### **“NOTICE OF DISAPPROVAL: DOE/SANDIA RESPONSES TO NMED'S NOTICE OF DISAPPROVAL FOR CORRECTIVE MEASURES EVALUATION REPORT FOR TECHNICAL AREA-V GROUNDWATER, JULY, 2005 SANDIA NATIONAL LABORATORIES, EPA ID# NM5890110518 HWB- SNL-05-027”**

## **Technical Area V Groundwater Investigation Work Plan**

### **Installation of Groundwater Monitoring Wells TAV-MW11, TAV-MW12, TAV-MW13, and TAV-MW14**

**Revision 1**

**Figure 1**  
**Existing TA-V Monitoring Wells**  
**and Proposed Soil-Vapor and**  
**Groundwater Monitoring Wells**

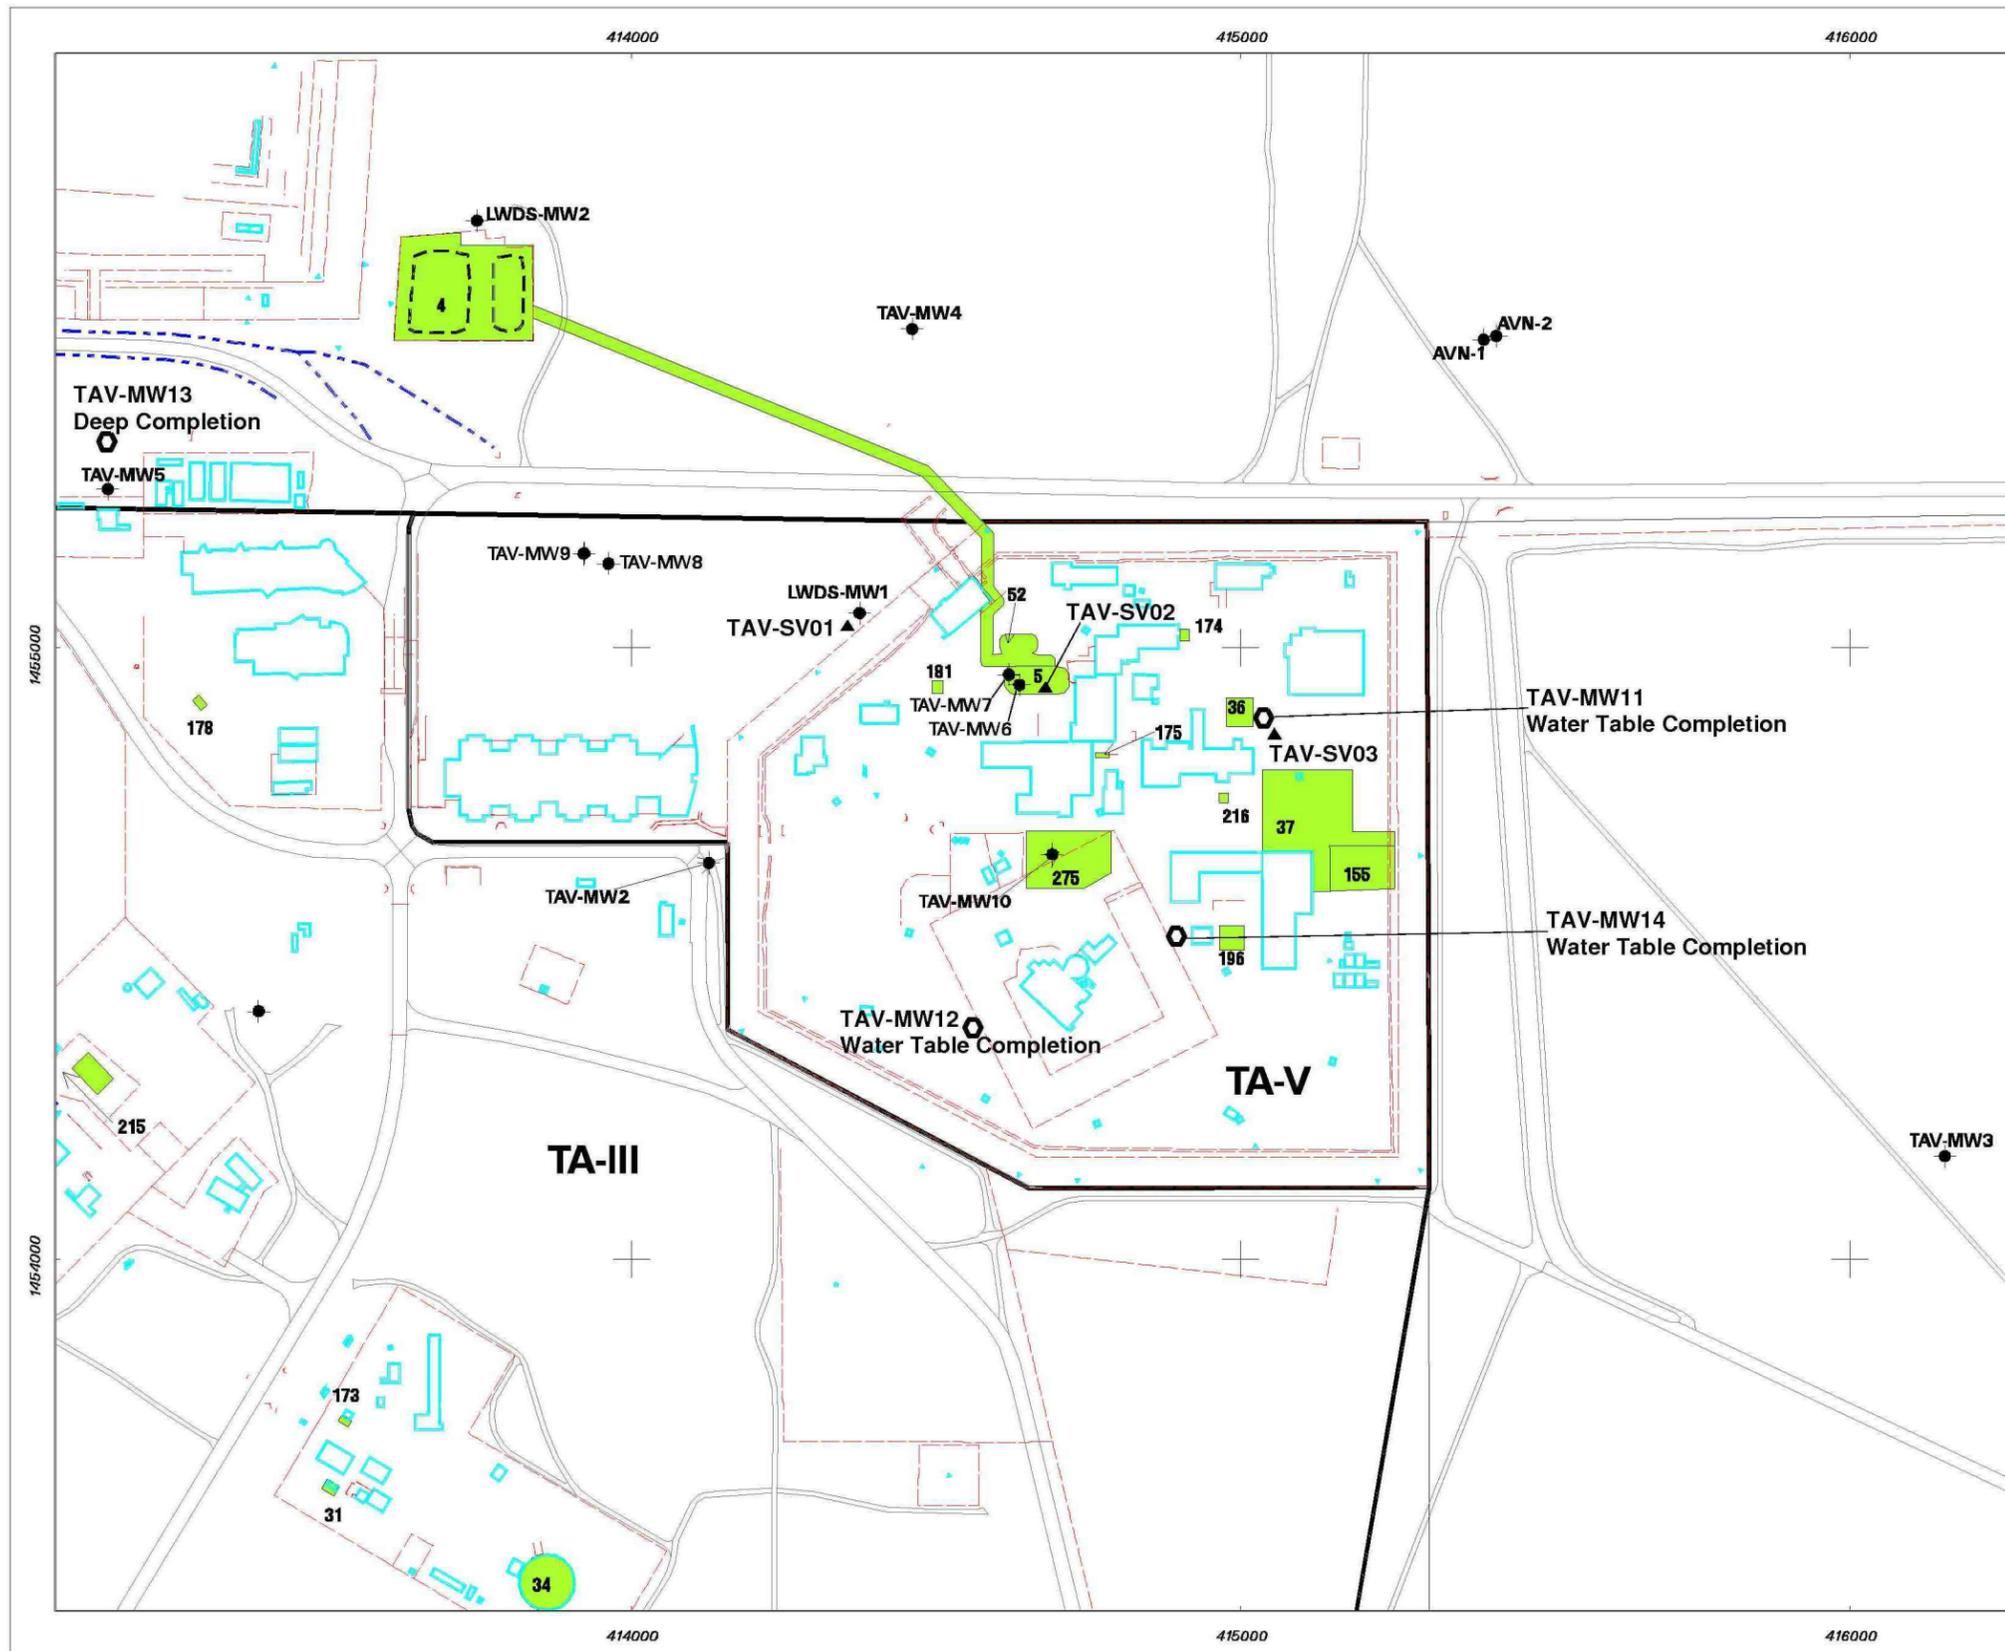
Figure 1 of the Work Plan shows the proposed locations of the three new groundwater monitoring wells. TAV-MW11 is proposed to be approximately 850 feet from the nearest existing monitoring well. NMED considers this too far to the east for the well to be effective at characterizing the extent of the plume. An appropriate location for the installation of TAV-MW11 is closer to the proposed location of TAV-SV03, about 425 feet from the nearest well (see Figure 1 enclosed with this letter).

As proposed in Figure 1 of the Work Plan, TAV-MW12 would be located approximately 625 feet from the nearest existing monitoring well. NMED considers this too far to the south for the well to be effective at characterizing the extent of the plume. An appropriate location for TAV-MW12 is considered to be a few hundred feet to the northwest of the proposed location (see Figure 1 of this letter).

**Groundwater at TAV-MW10 exhibits TCE above the maximum concentration limit (MCL) and has an increasing nitrate-concentration trend suggesting that nitrate levels are beginning to exceed the MCL (see Figure 2 enclosed with this letter). This well can therefore no longer be used to delineate the outline of the plume (i.e., the area of the plume where concentrations are below MCLs). Another well is needed to characterize the plume in this area of Technical Area V (TA-V). Even if groundwater samples from TAV-MW11 and TAV-MW12 are nondetect with respect to TCE and nitrate, TAV-MW10 would show the plume outline is not resolved. A suggested location for this additional well is shown in Figure 1 of this letter.**

**Response:** DOE/Sandia do not agree with the NMED's proposed location for TAV-MW11, not only for the logistical reasons previously discussed with NMED (SNL/NM September 2008), but also for technical reasons. DOE/Sandia do not believe this location will be effective at characterizing the extent of the plume. NMED believes this area to be a potential source of VOCs in the vadose zone and have required DOE/Sandia to install a soil vapor monitoring well. If this is a source of VOCs in the vadose zone, then a groundwater monitoring well at NMED's proposed location will not bound the plume as intended. DOE/Sandia believe the aerial extent of the plume would be bounded by the location originally proposed in the Work Plan. However, groundwater monitoring well TAV-MW11 will be installed as directed by the NMED. The Work Plan (Appendix A) has been modified to accommodate the revised location of TAV-MW11.

**Response:** DOE/Sandia do not agree with the NMED's proposed location for TAV-MW12. DOE/Sandia prepared and submitted the Work Plan with the proposed location for TAV-MW12 based on verbal concurrence with the NMED (SNL/NM September 2008).

Based on technical considerations, DOE/Sandia do not believe this location will be effective at characterizing the extent of the plume. As shown on Figure 1 of the second NOD, NMED's proposed location may be very near, or within the 5 µg/L contour for TCE. If that is the case, DOE/Sandia would be required to install an additional well to bound the plume. DOE/Sandia believes the information obtained at the location originally proposed is sufficient to protect human health. Considering the depth to groundwater is approximately 500 ft and the nearest receptor/drinking water well is greater than 4 miles away, DOE/Sandia believe that installing groundwater monitoring wells on a 300 or 400 ft spacing is excessive.

DOE/Sandia believes the aerial extent of the plume would be bounded by the location originally proposed in the Work Plan. However, groundwater monitoring well TAV-MW12 will be installed as directed by the NMED. The Work Plan (Appendix A) has been modified to accommodate the revised location of TAV-MW12. It should be noted that approximately 40% of the polygon labeled "NMED suggested location – TAV-MW12" on Figure 1 of the second NOD is within the controlled area of the Sandia Pulsed Reactor Facility, and groundwater monitor wells can not be installed within this area for security reasons. Much of the remainder of the suggested location polygon is occupied by aboveground and underground structures and utilities that preclude well installation.

For reasons similar to those outlined above in the response to Comment 2, DOE/Sandia do not believe the location of NMED's proposed "new" well (hereinafter identified by TAV-MW14) will be effective in characterizing the extent of the plume. As with NMED's proposed location for TAV-MW12, NMED's proposed location of TAV-MW14 may be very near, or within the 5 µg/L contour for TCE. DOE/Sandia suggest that installing TAV-MW14 at a location 200 to 300 feet southeast of NMED's proposed location would sufficiently characterize the plume while being protective of human health. However, groundwater monitoring well TAV-MW14 will be installed as directed by the NMED. The Work Plan (Appendix A) has been modified to accommodate the addition of TAV-MW14. It should be noted that approximately 70% of the polygon labeled "NMED suggested location – new well" on Figure 1 of the second NOD is within the controlled area of the Sandia Pulsed Reactor Facility, and groundwater monitor wells can not be installed within this area for security reasons. Much of the remainder of the suggested location polygon is occupied by aboveground and underground structures and utilities that preclude well installation.
